**RE: 88 Newton Road, Wetherill Park – DA 205.1/ 2024
Letter of Response to Stakeholder Comments**

This letter has been prepared in response to transport and parking matters raised in the Fairfield City Council (Council) email dated 21 March 2025.

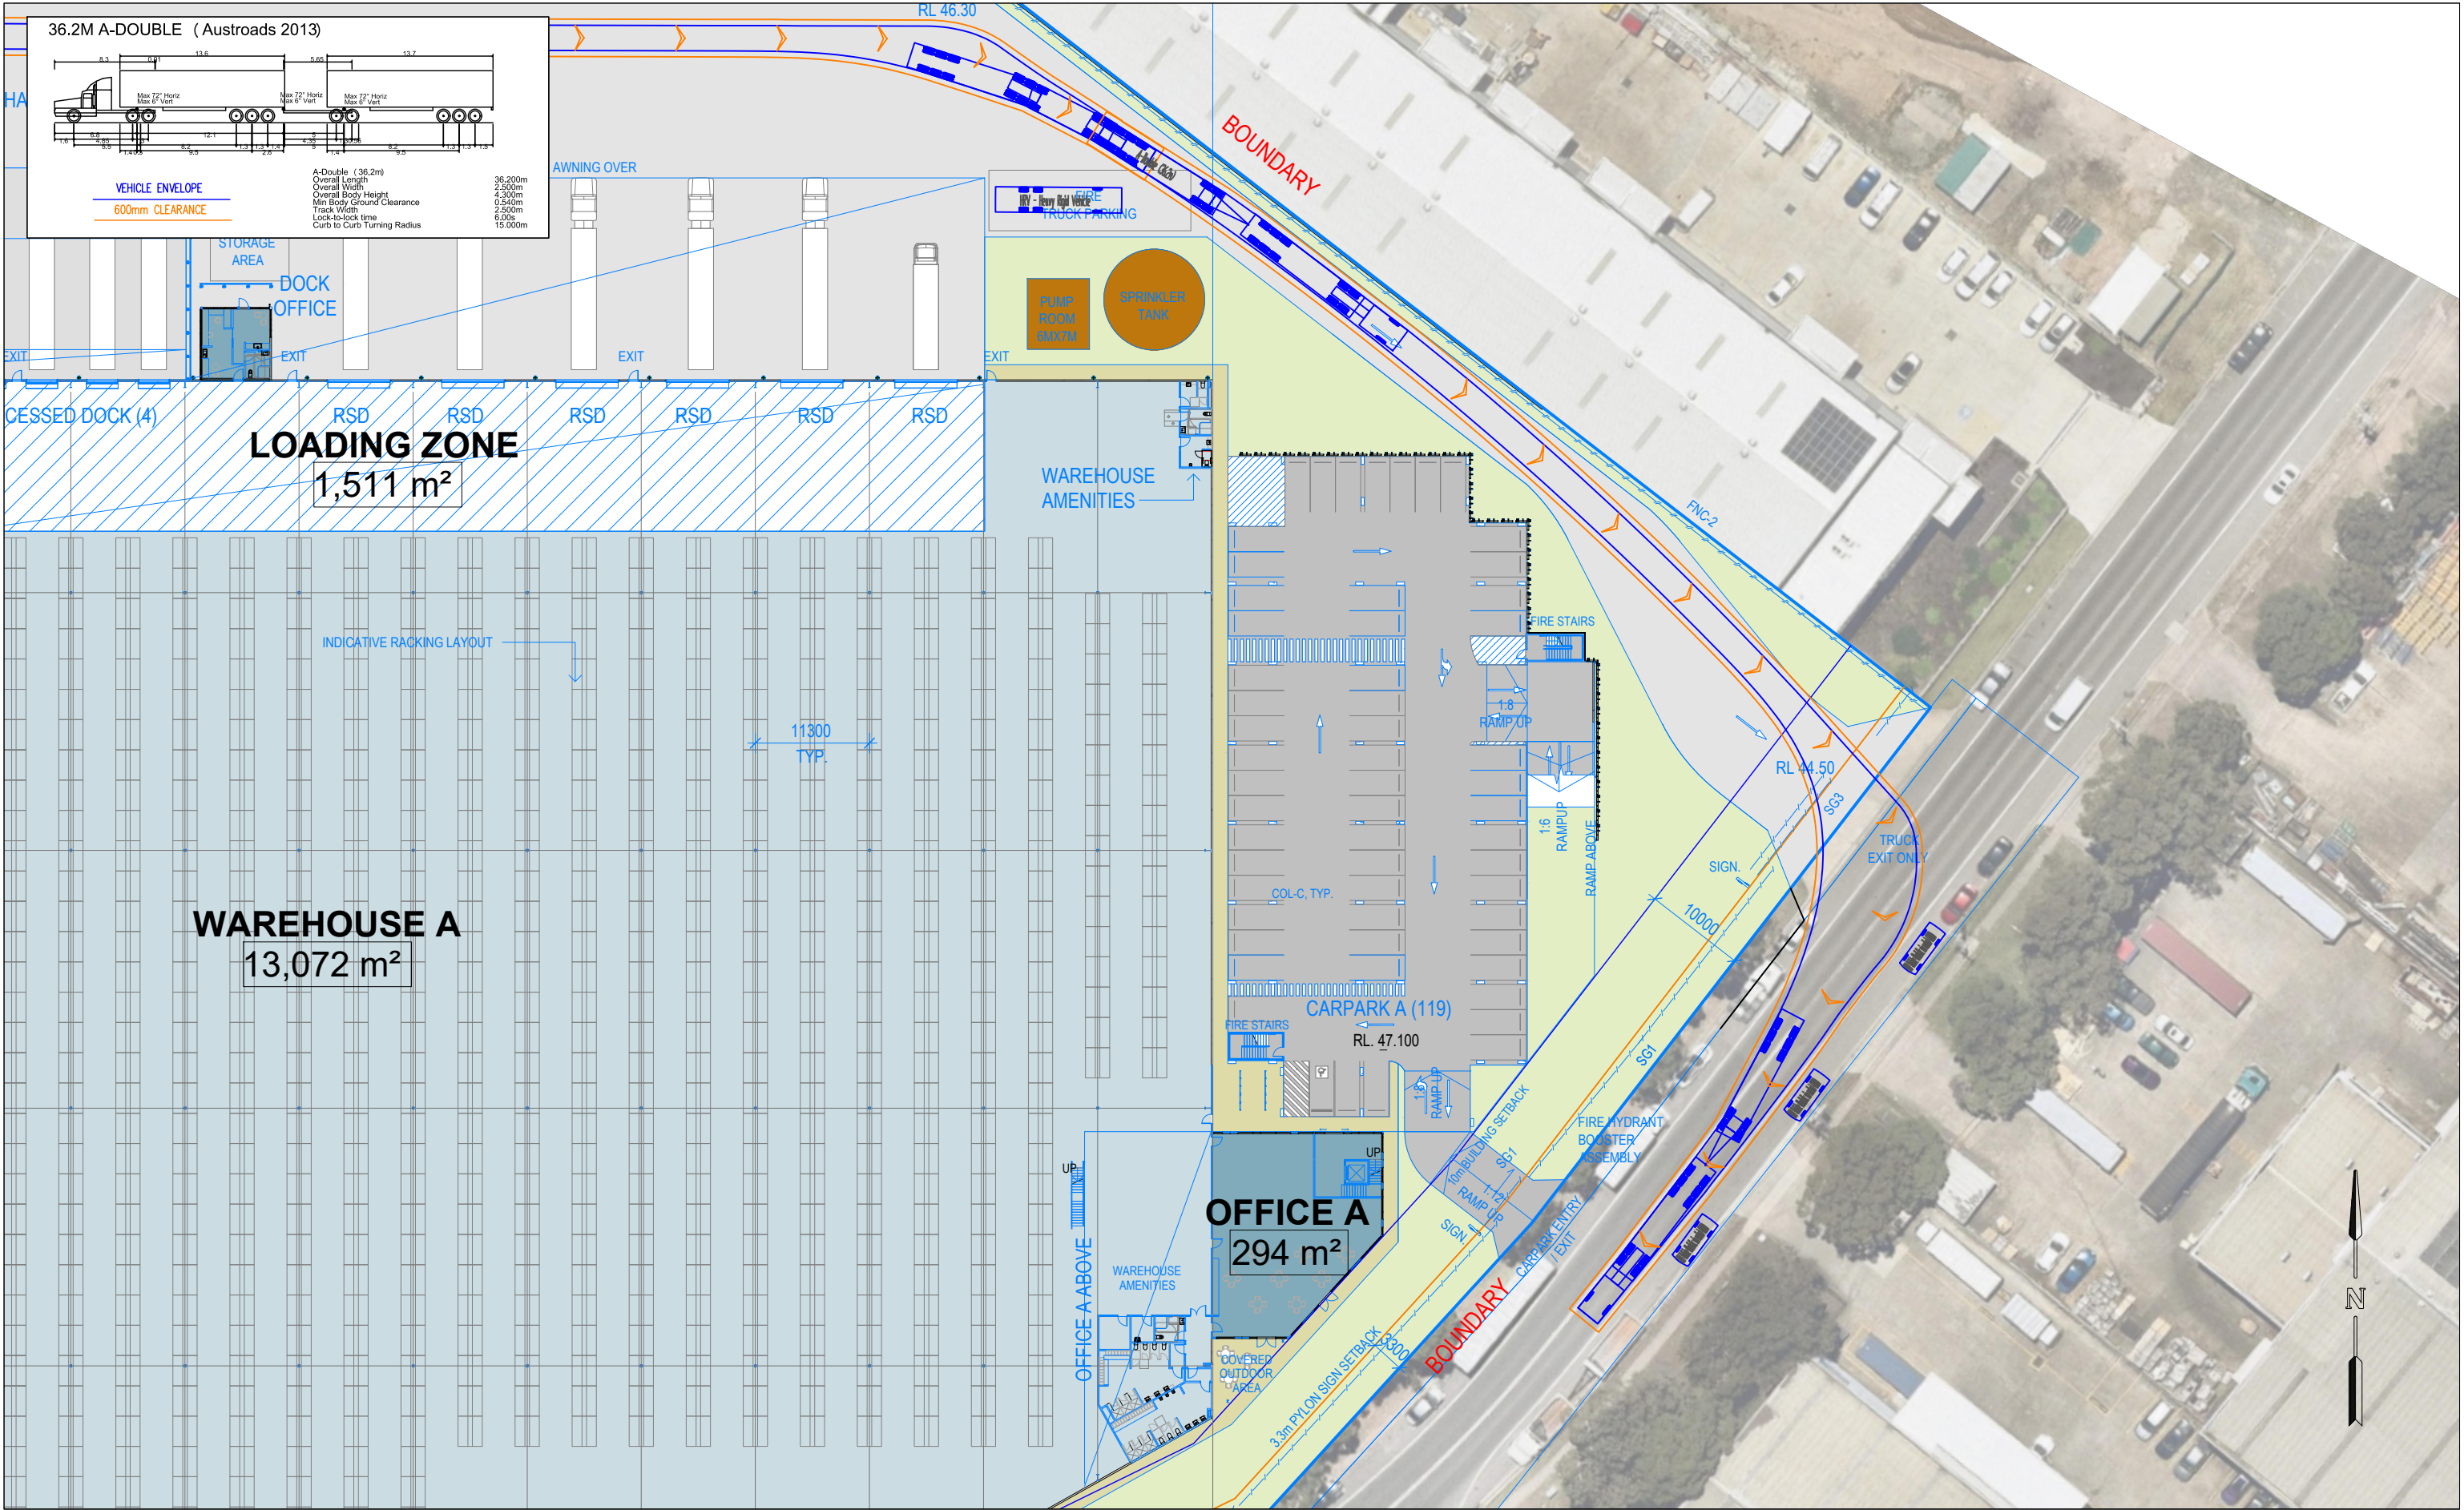
***Point 1:** The swept path diagrams indicate that a 36m A-Double vehicle turning right out of the site would encroach into a parking lane, potentially running into the path of a parked vehicle on Newton Road opposite the site.*

The swept paths have been updated and included as **Attachment 1**, which confirm that A-Doubles can turn right out on exit without obstructing through traffic or impacting on-street parking on both sides of Newton Road.

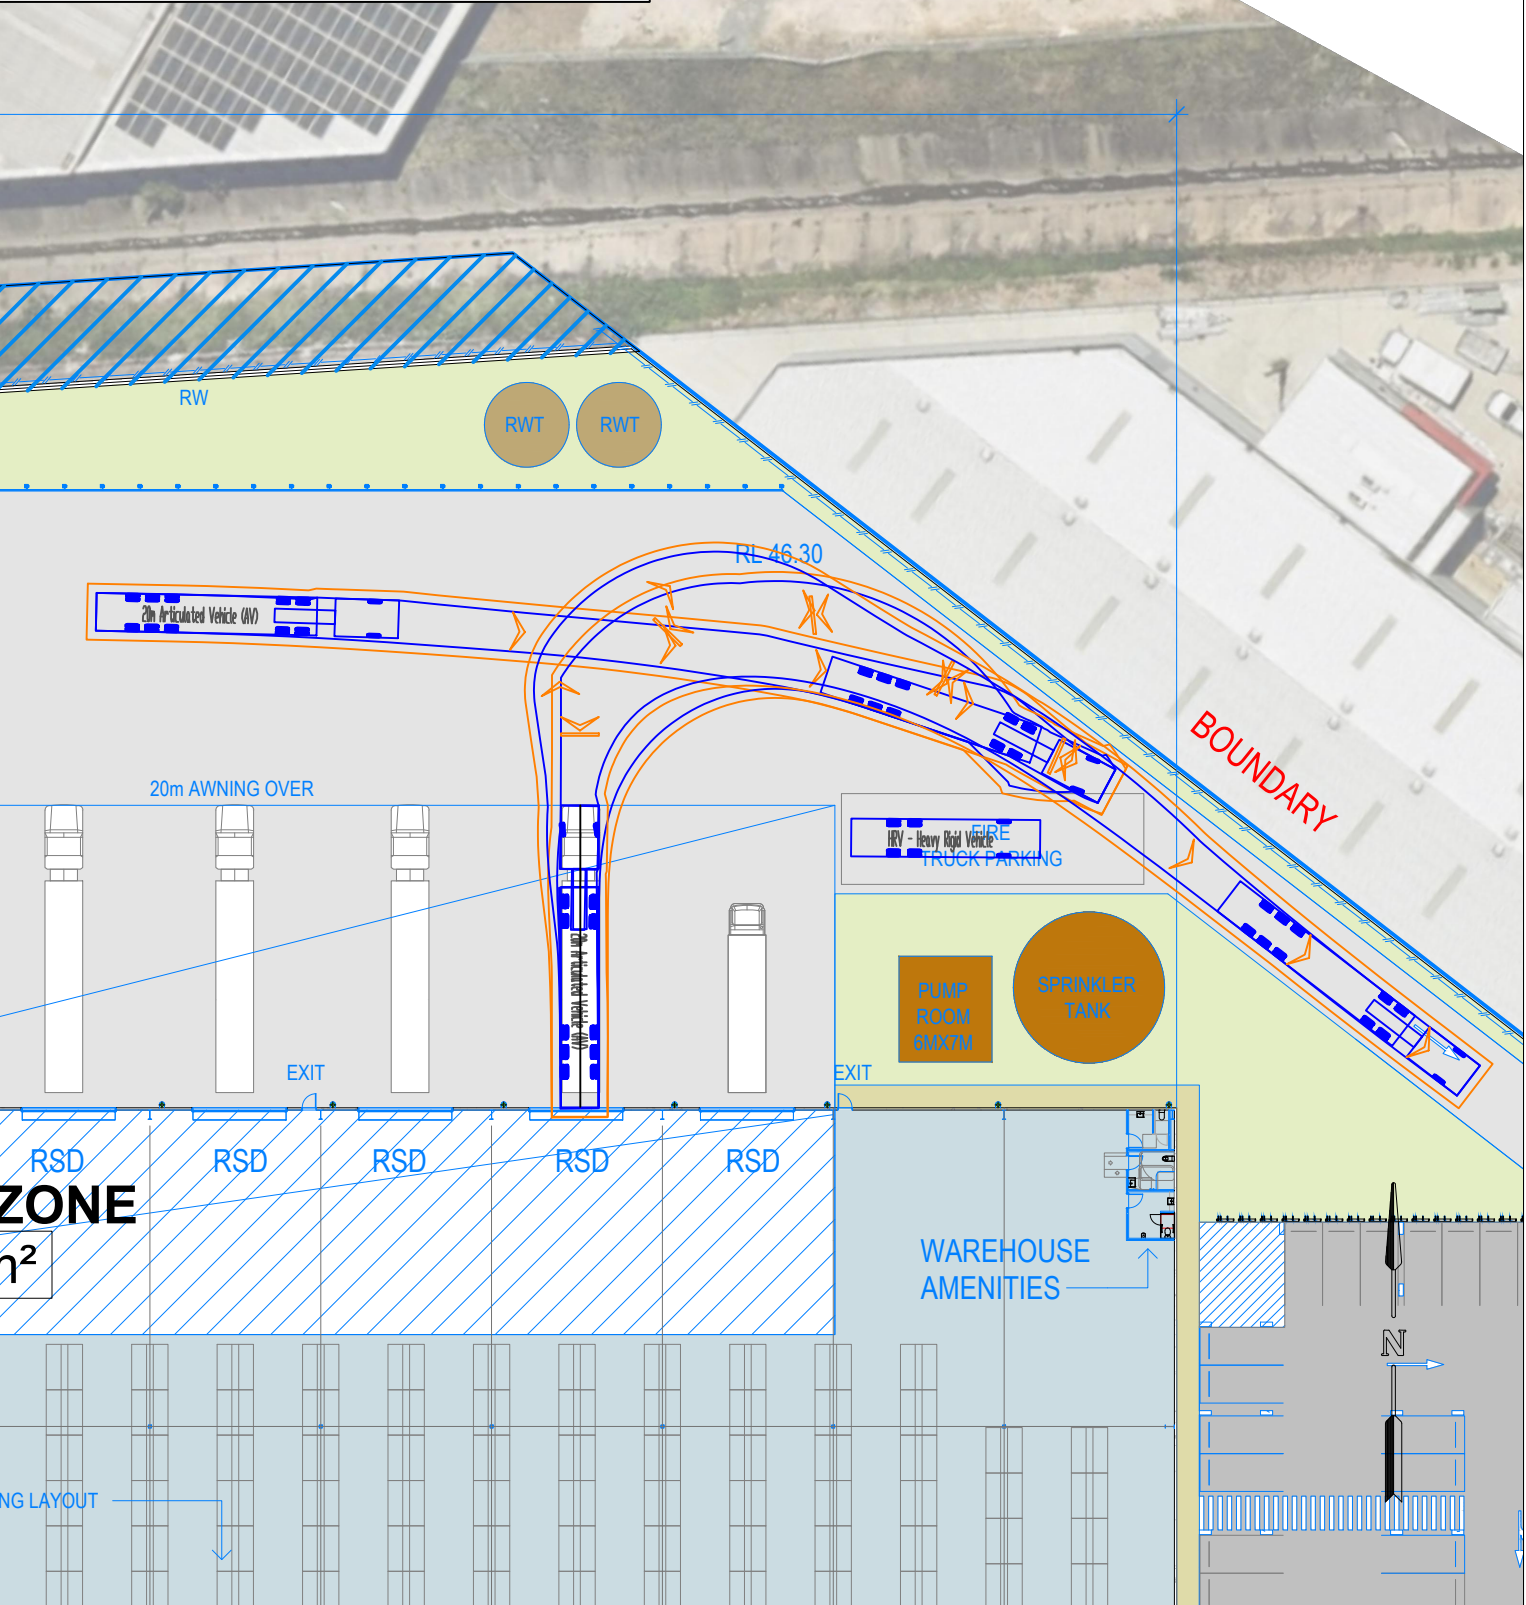
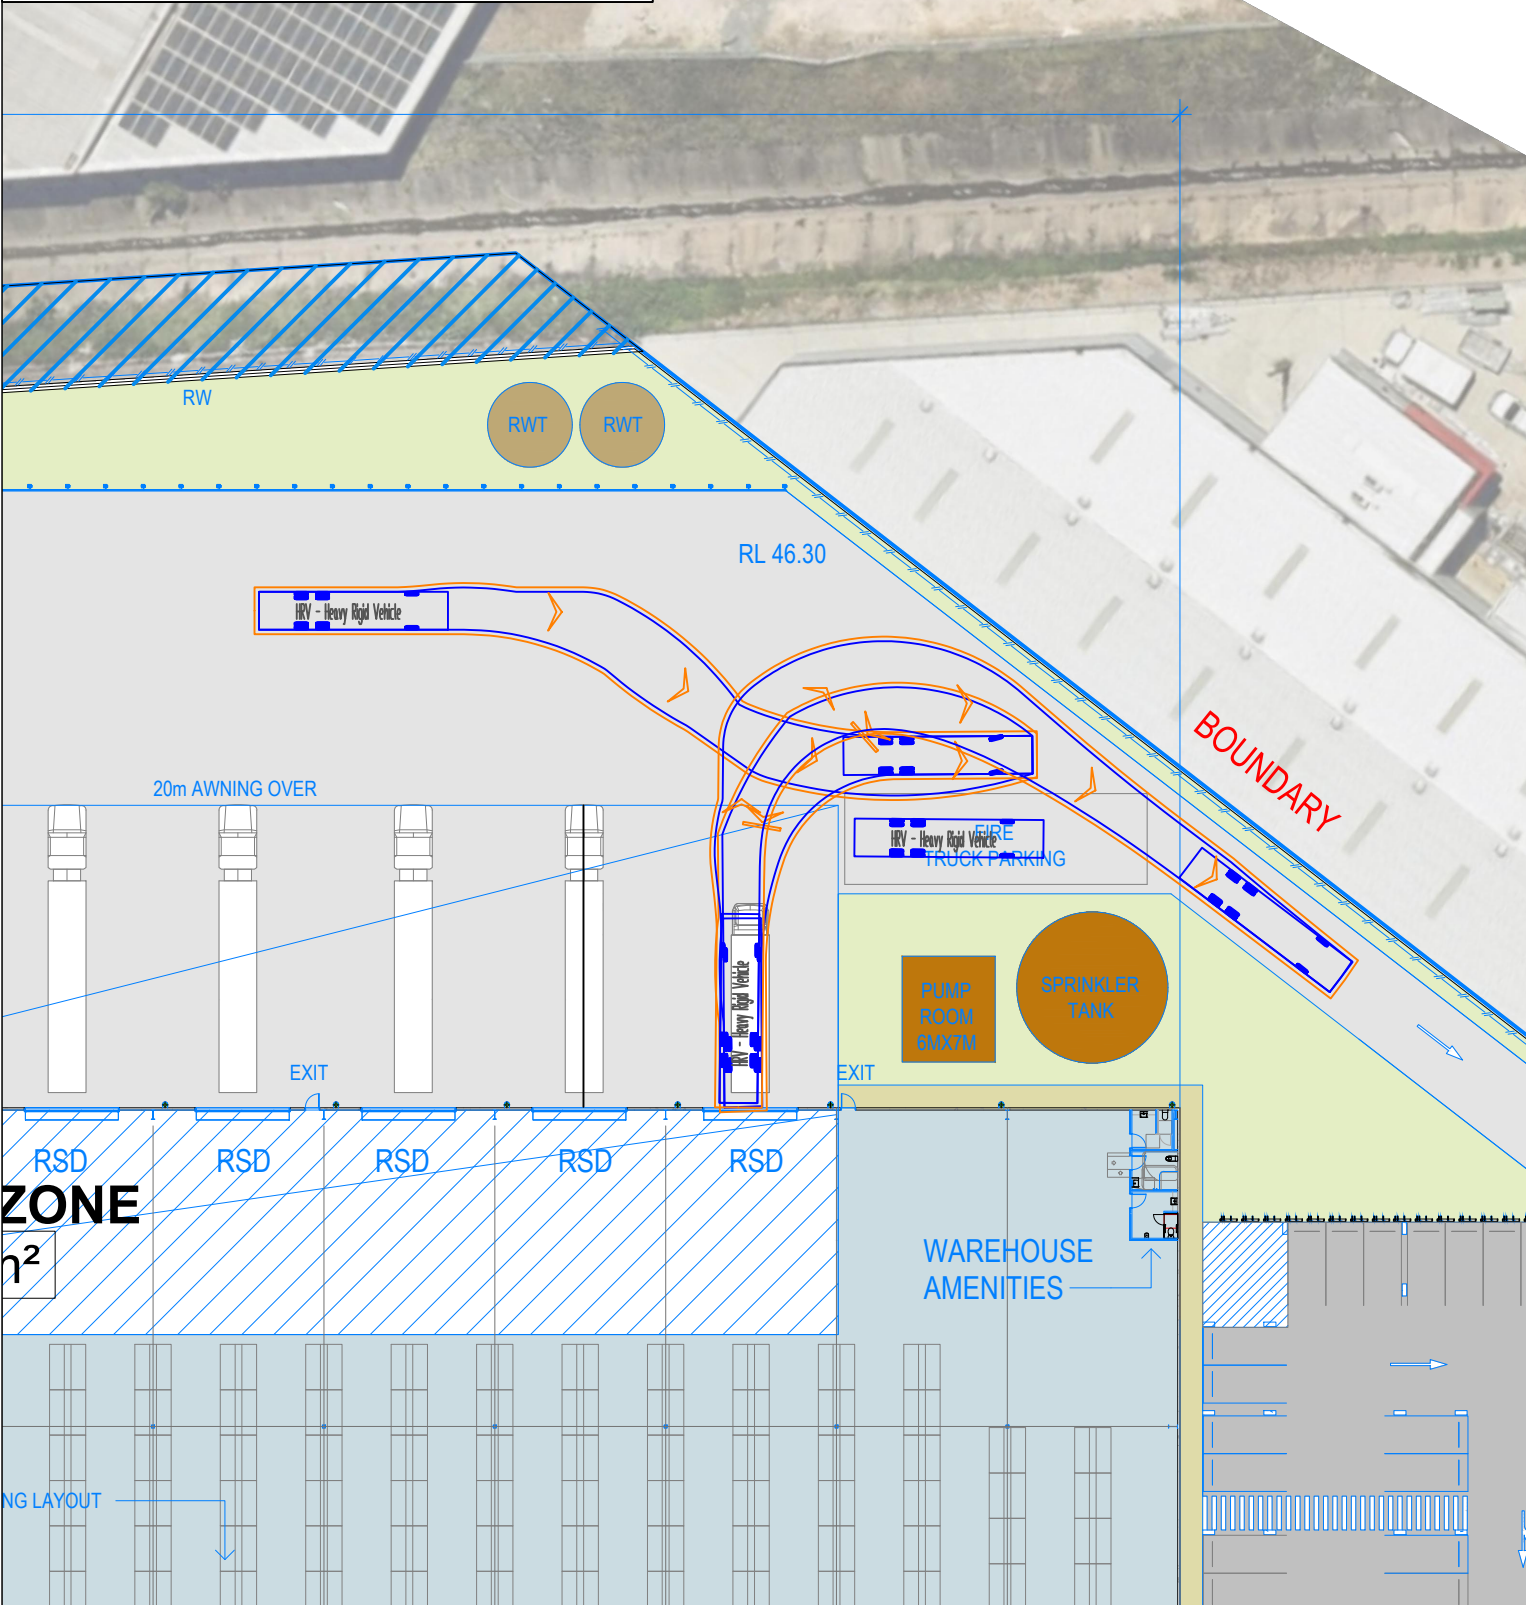
***Point 3.** The swept path diagrams have indicated that the fire truck parking space close to the exit driveway of the site (adjacent to Warehouse A) would impact vehicles manoeuvring at/near this location. If vehicles are allowed to drive onto the fire truck parking space, they could potentially hit the parked fire truck when exiting the driveway; and*

The internal site layout, including on-site car parks have been designed to be fully compliant with AS2890.1:2004 and AS2890.6:2022. All circulation aisles, car space dimensions, headroom clearances and driveway/ ramp gradients and transitions are compliant. Swept paths included as **Attachment 1** confirm that a fire truck parked within the fire truck standing area would not obstruct vehicles manoeuvring near this location.
